Service Bulletin

SUBJECT: Special Coverage Adjustment - Shift Lever May Not Display Correct Gear

MODELS: 2007-2008 Saturn AURA
Equipped with 4-Speed Automatic Transmission (ME7/MN5)

The service procedure in this bulletin has been revised to include the installation of a cable kit (clam shell). Please discard all copies of bulletin 11175.

1765068

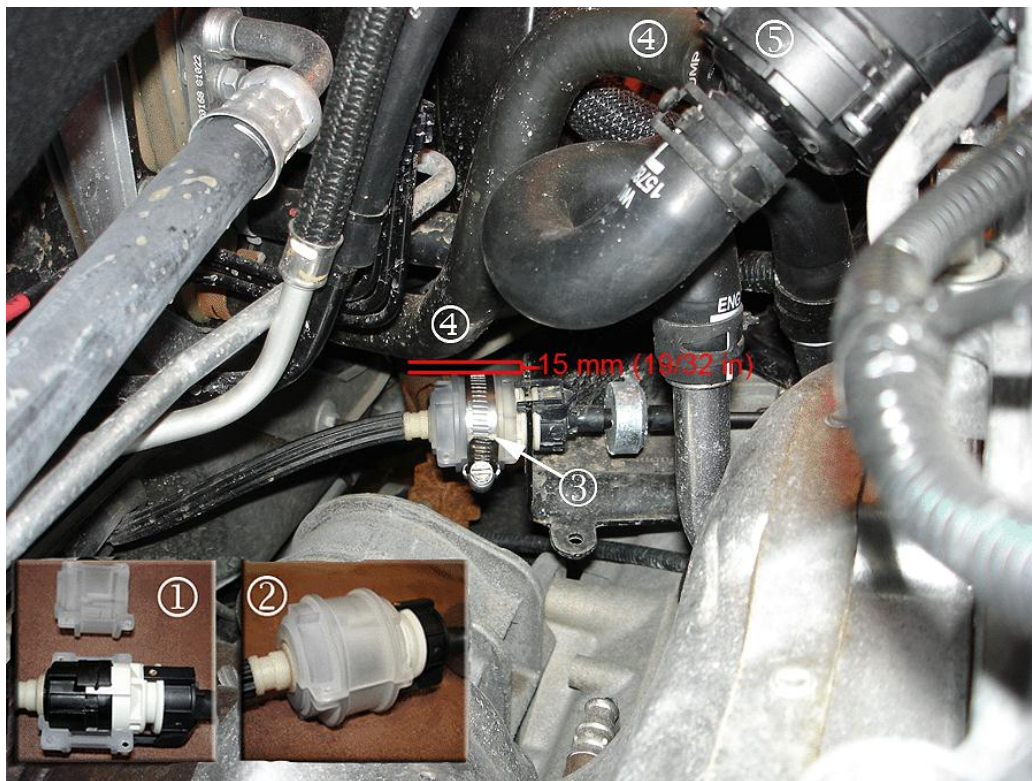
- Verify that the transmission shift cable requires replacement. Refer to the appropriate diagnostic information in SI. Pay particular attention for any signs of fraying or fracture.
 - If the transmission shift cable does NOT require replacement, no further action is required. Inform the customer that any additional diagnosis and repairs are not covered under this special coverage.
 - If the transmission shift cable requires replacement, proceed to Step 2.
- Remove the floor shift control cable. Refer to *Floor Shift Control Cable Replacement* in SI.

- Remove and discard the cable bracket (4).
- Install a new floor shift control cable and new bracket. Refer to *Floor Shift Control Cable Replacement* in SI.
